Metropolitan
St. Louis Sewer
District

July 25, 2012

RE: Pavedrain Articulating Permeable Paving Surface - A Structural BMP

**PERMEABLE - ARTICULATING CONCRETE BLOCK/MAT
TYPICAL SECTION**

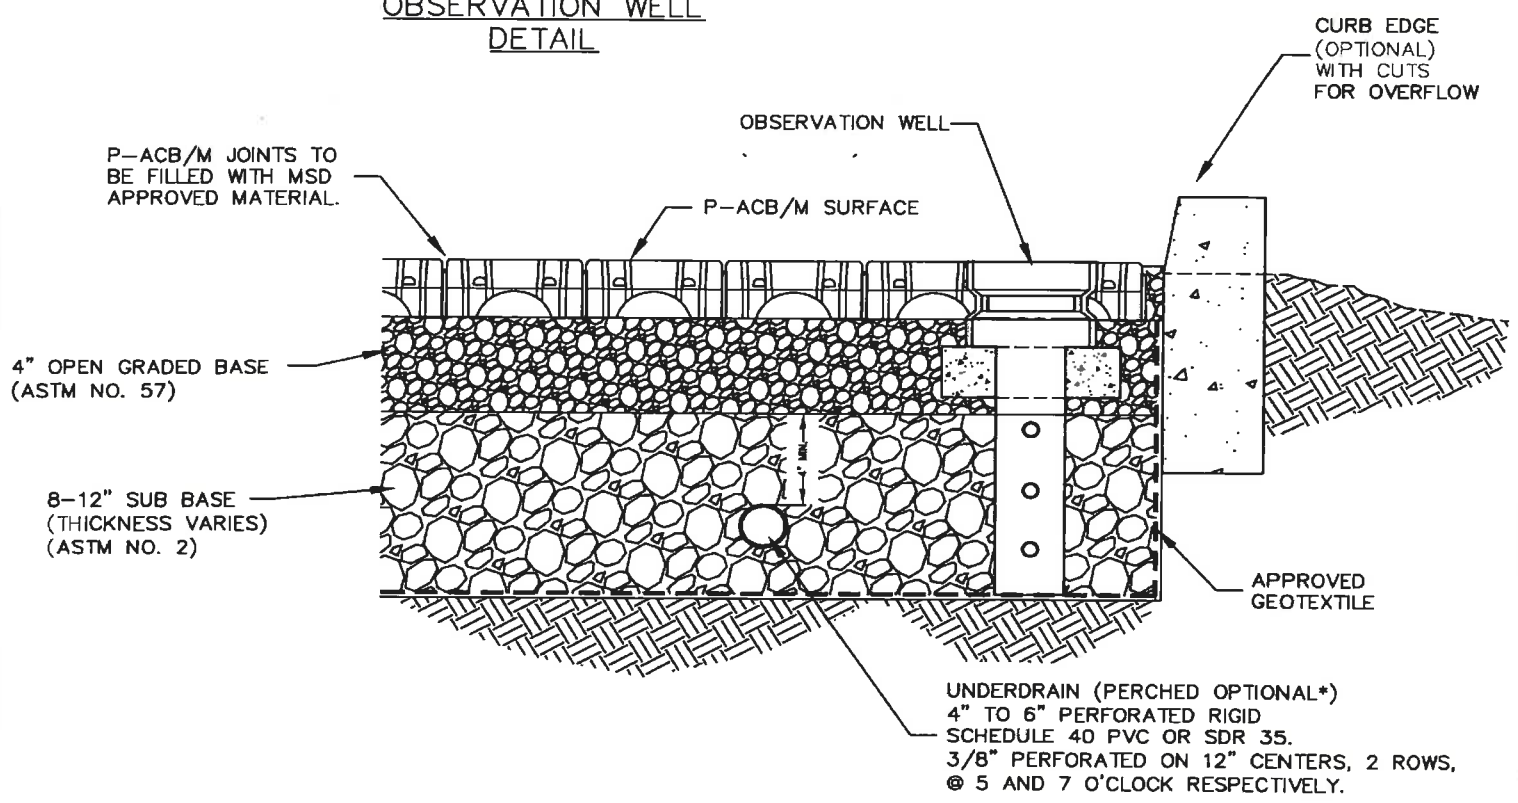
1. Proposed uses and designs of Pavedrain, must be in general conformance with the information and methodologies provided by ASP Enterprises and PaveDrain LLC received March 28, 2012 and the detail attached to this approval letter.

2. Channel Protection Volume (CPv) storage may be provided in the sub base stone beneath the articulating block and bedding layer.
3. The articulating block mat shall rest on a 4-inch thick layer of base stone (ASTM No. 57 or similar size), and a layer of subbase stone (ASTM No. 2 or similar size), all underlain by MSD type 4 filter fabric. The thickness of the subbase will vary depending on storage and anticipated traffic loads. However, a minimum 12-inch thick subbase will be required for all applications.
